Application for Two Variances, Each Subject to Four Conditions, Respecting One Third Party Electronic Ground Sign

1150-1176 Morningside Ave

September 12, 2025

Aerial View - Adjacent Properties Uses

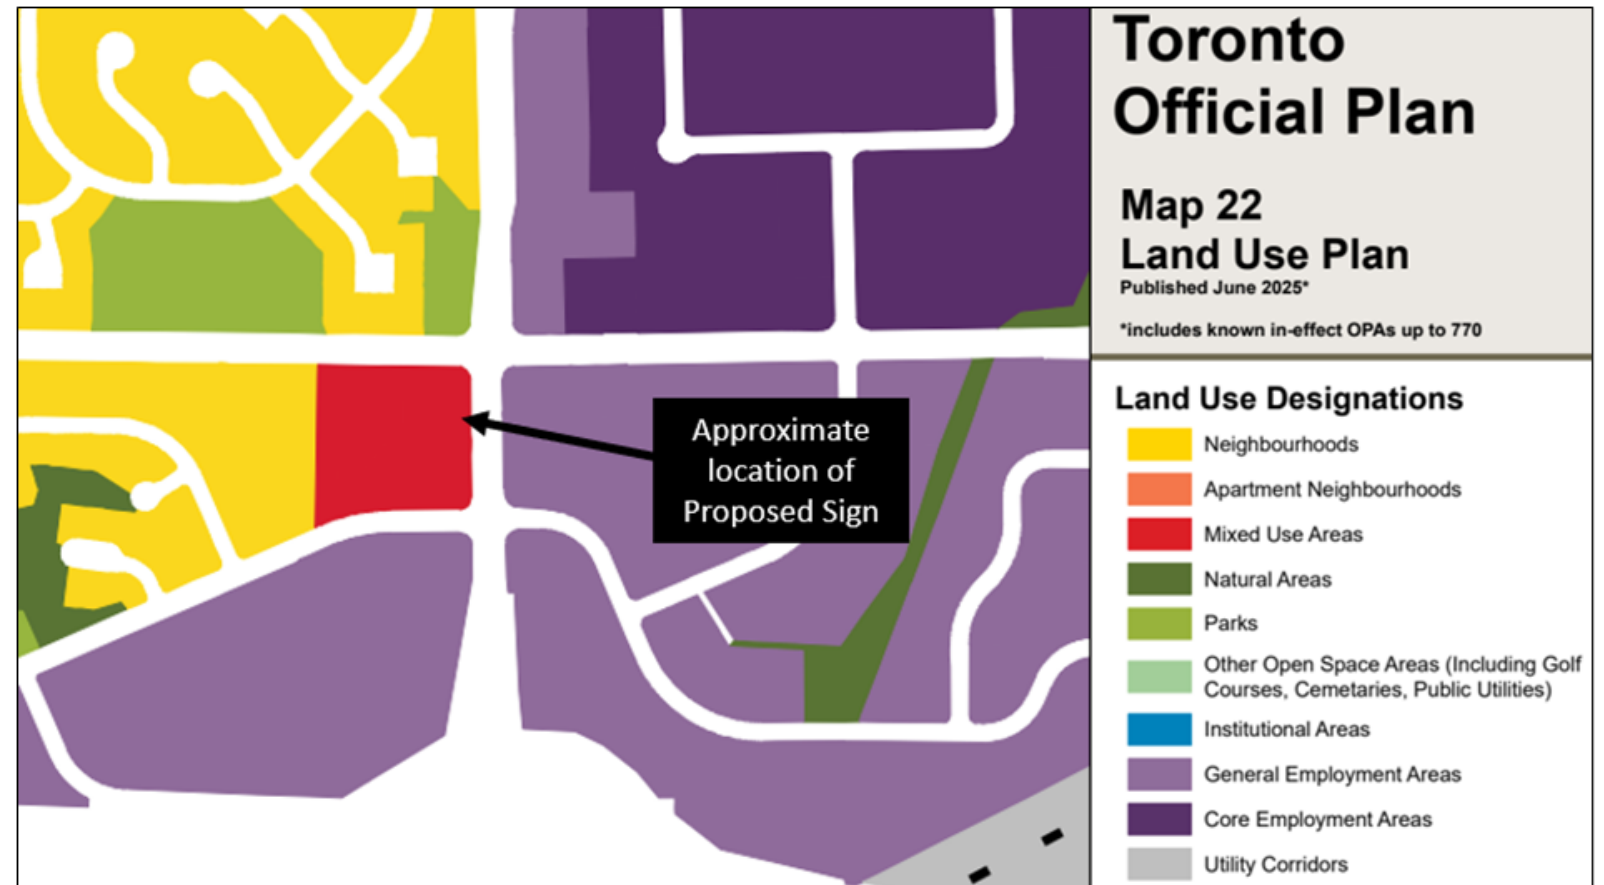
- The Subject Premises is in a CR Sign District featuring a retail plaza, surrounded by commercial and employment uses; adjacent properties include Malvern Woods park (OS Sign District) and a place of worship (I Sign District).

- Electronic ground signs are not permitted in CR Sign Districts, and the Proposed Sign would face OS and I Sign Districts within 250 metres, contrary to separation requirements.

- The Applicant states that the impactful light would only reach 50 metres, and therefore not impact I and OS Sign Districts approximately 75 and 82 metres away, respectively.

- Moreover, existing trees and buildings block views from sensitive areas, and nearby properties are mostly C and E Sign Districts with no residential uses.

- Staff confirm nearby development applications are for non-sensitive uses, and that residential uses are not permitted on the Subject Premises under the Zoning By-law.

- **CBO Opinion:** Subject to the conditions, this criterion has been met.

Official Plan Map 22 Land Use Plan –
1150-1176 Morningside Ave

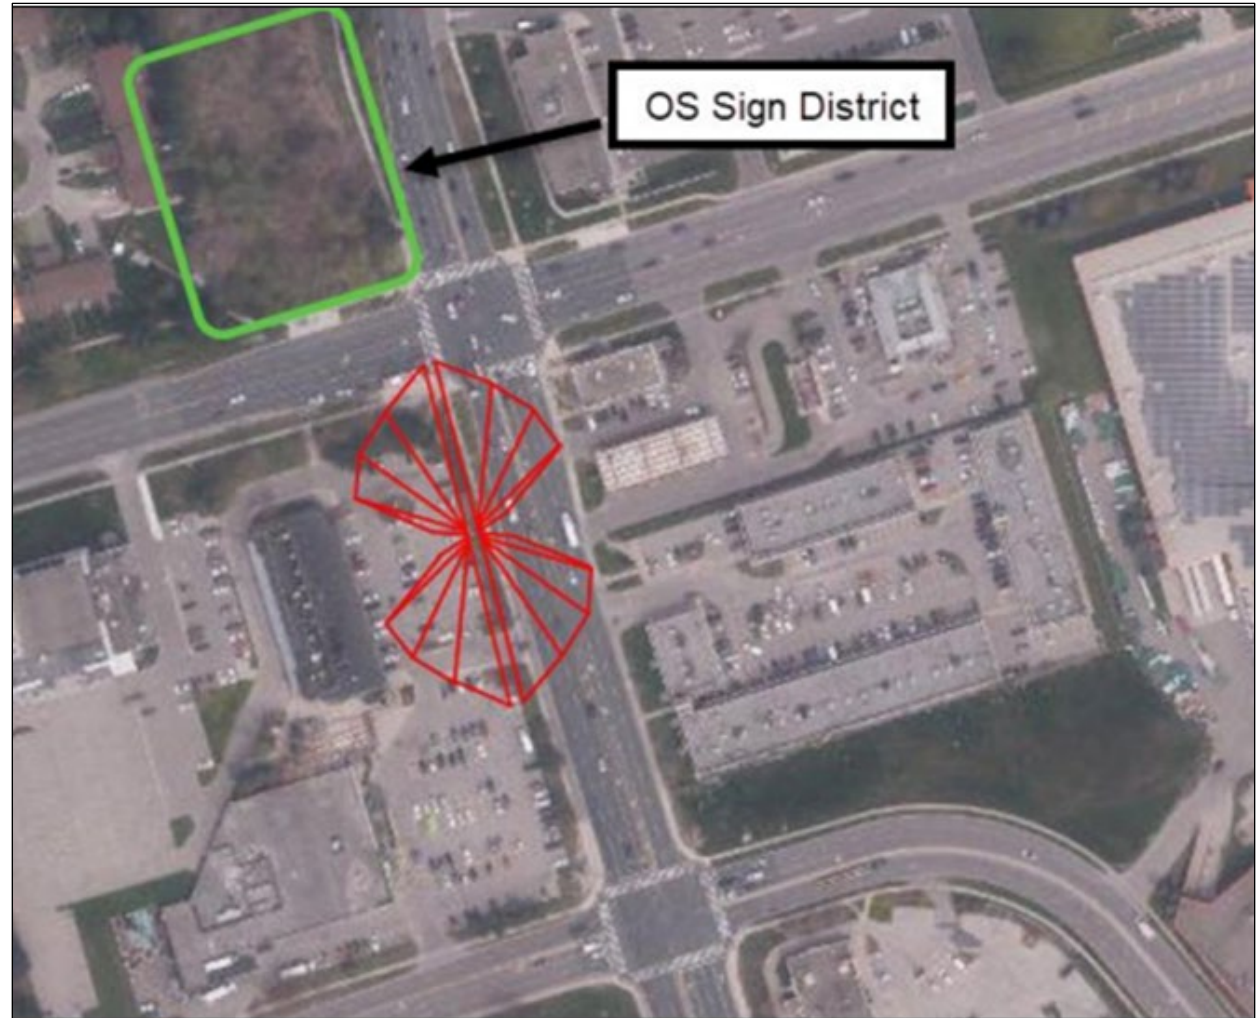
- The Subject Premises is designated Mixed Use Area in the Official Plan and contains two low-rise commercial buildings, consistent the CR Sign District designation.

- Adjacent lands include Employment Areas to the east and south, and Parks to the north; the CBO finds no conflict between third party signs and Employment policies.

- Policies and strategies supported by EV charging station do not imply the sign itself supports Official Plan objectives. If granted, sign could be installed despite of the EV charging station.

- Submissions indicate Proposed Sign supports OP objectives by enhancing public realm, respecting neighborhood character, supporting local economic activity, and mitigating land use conflicts, without negatively impacting adjacent commercial, industrial, or open space uses.

- No major use changes are expected in the area, residential uses are restricted.
- **CBO Opinion:** The Applicant has provided sufficient evidence that the Proposed Sign supports Official Plan objectives for the site and surrounding area; this criterion is met.

Dispersion of Light Diagram
(from Submissions)

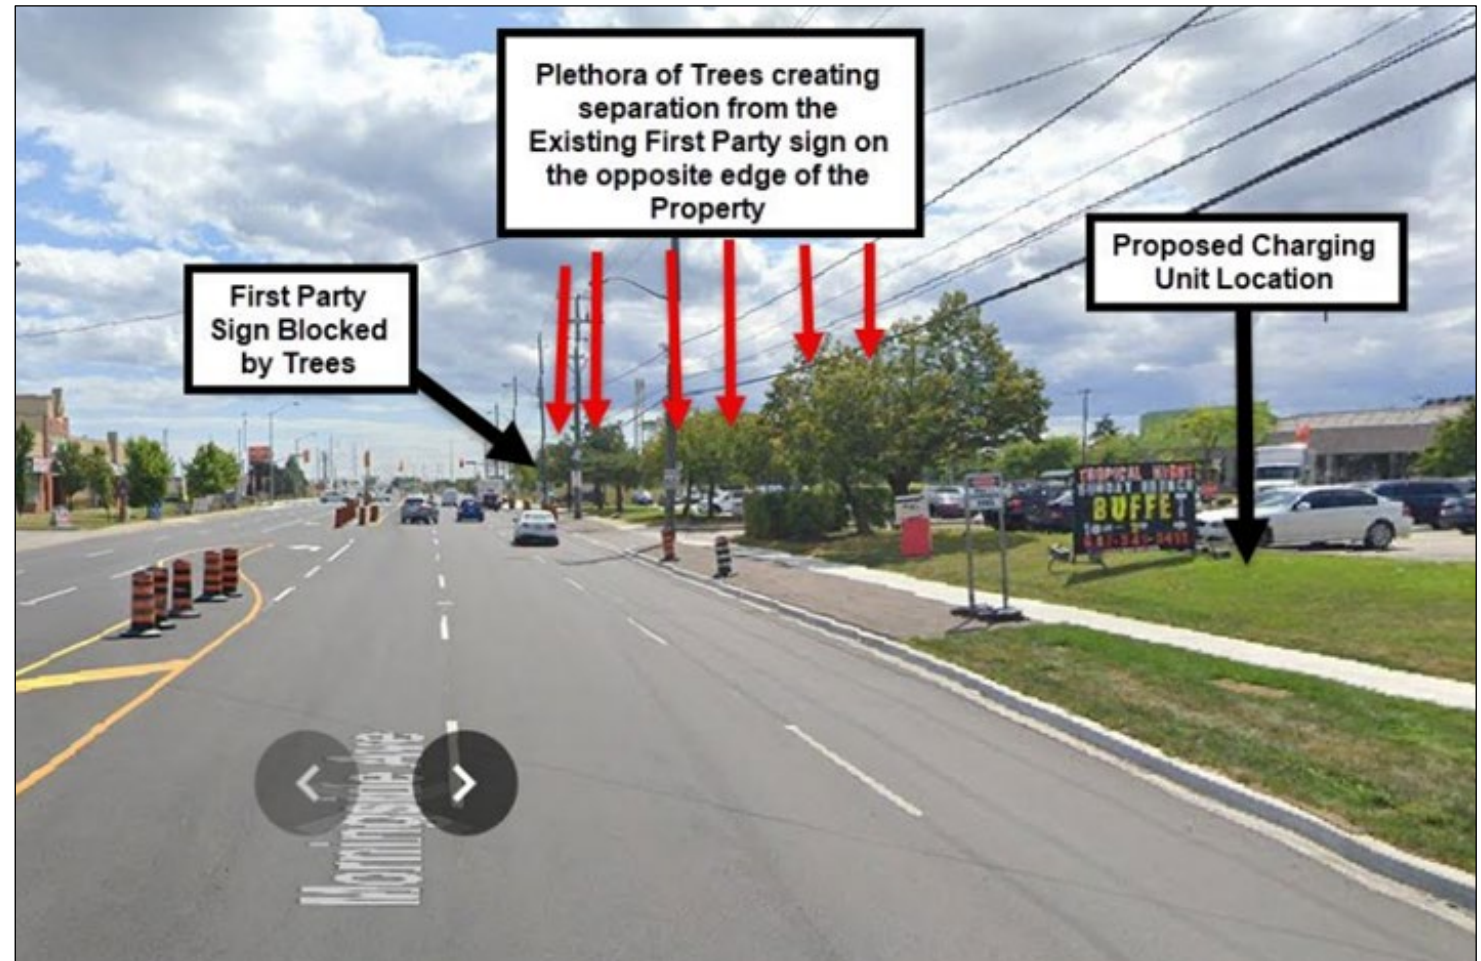
- A variance is required for proximity to Highway 401 (150m vs. 400m required), but grade differences and Proposed Sign's height prevent visibility from highway lanes.

- While the sign may be visible from on/off ramps, Applicant contends, and staff agree, it would not interfere with driver decision points or create safety concerns.

- The Proposed Sign would face I and OS Sign Districts within 250 metres, contrary to Sign By-law separation rules; however, the Proposed Sign's light output is minimal beyond 50 metres. Moreover, buildings and trees obstruct visibility.

- The Applicant asserts, and staff agree, that illumination impacts on Malvern Woods and nearby natural features would be negligible, with light levels comparable to a full moon.

- **CBO Opinion:** Based on the Applicant's submissions and staff's findings, the Proposed Sign, subject to the height condition, would not adversely affect adjacent premises; this criterion is met.
